18 Crowsport, Hamble-le-Rice, Southampton, SO31 4HG – application no. H/23/94973

Please accept this letter as a strong objection to the above application.

The following photographs shows the context of the proposed dwellings within the midst of single storey buildings:

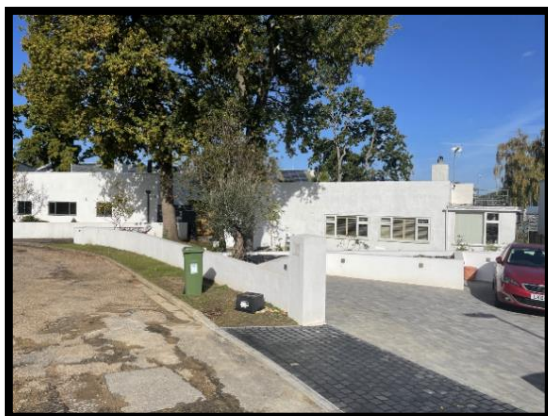
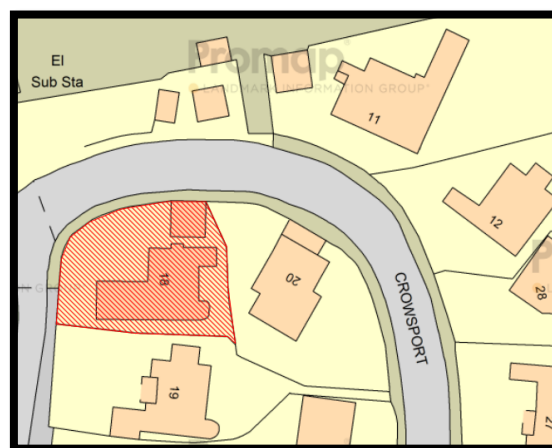
Whilst it is noted that a number of local dwellings are two-stories in height, it is noted that in the part of Crowsport that there are a number of single storey dwellings to include nos. 11, 12, 19 and 20 Crowsport. The character of this part of Crowsport is therefore one of single storey buildings and, as noted from the conservation area appraisal, the provision of first floor additions erodes the character of the estate. Given the local cluster of single storey buildings it is argued that to allow the first-floor addition will therefore unacceptably harm the character and appearance of the conservation area.
